Bulletin No.: L17-001
Release Date: 01/30/17
Effective Date: Immediately
Supersedes: L16-006
Completion Date: 3/1/17*
Pages: 2

SERVICE BULLETIN

Ride Manufacturer: Larson International Inc. Affected Production Dates: 1998-2016
Ride Name: Giant Loop Affected Serial Nos.: 1,2,4-14

Abstract Of Issue:

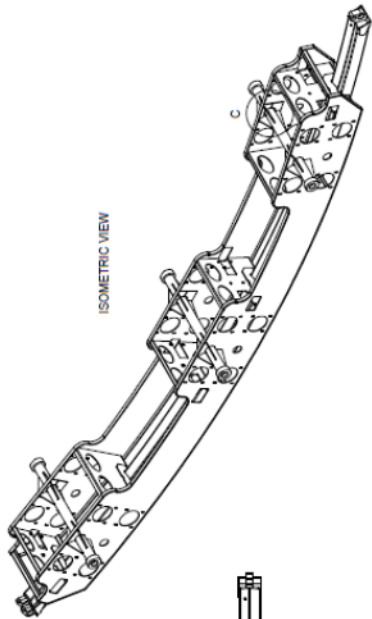
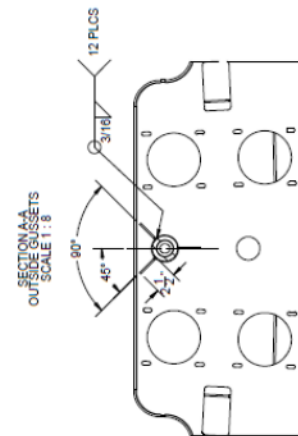
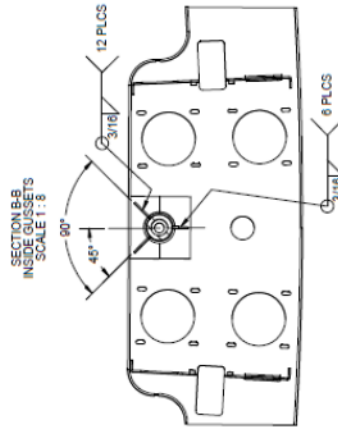
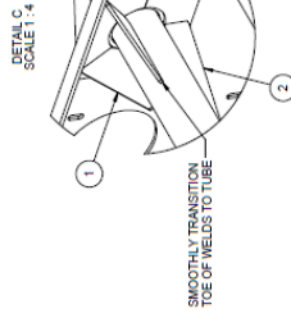
Indications have been found on the undercarriage weldment mounting cross tubes and the adjacent area during routine inspections. This bulletin has a revised drawing with one additional gusset at each location. * If gussets have already been installed from the previous bulletin, this additional gusset can be installed during the next annual, no later than 3/1/18.

1. Update maintenance procedures to include the following ongoing inspections:
 - a. Monthly Inspection – visual inspection of undercarriage cross tubes and adjacent area (as shown below).
 - b. Annual Inspection (or 2,000 operating hours) – NDT MT of undercarriage cross tubes and adjacent area (as shown below).
2. Install gussets as shown on drawing “Undercarriage Repair 1-30-17”. NDT MT prior to gusset installation. Contact manufacturer for gussets and weld procedures.

NOTES:
 1) WRAP WELD AROUND ENDS OF GUSSET
 TO BLEND THE GUSSET WELD TO THE TUBE
 TO MAKE A SMOOTH TRANSITION
 (SEE DETAIL C)
 2) NOT (MT) ALL WELDS AFTER COOLED.
 NO INDICATIONS PERMITTED.
 * MATERIAL NOTE:
 ASTM A38 IS ALSO ACCEPTABLE MATERIAL
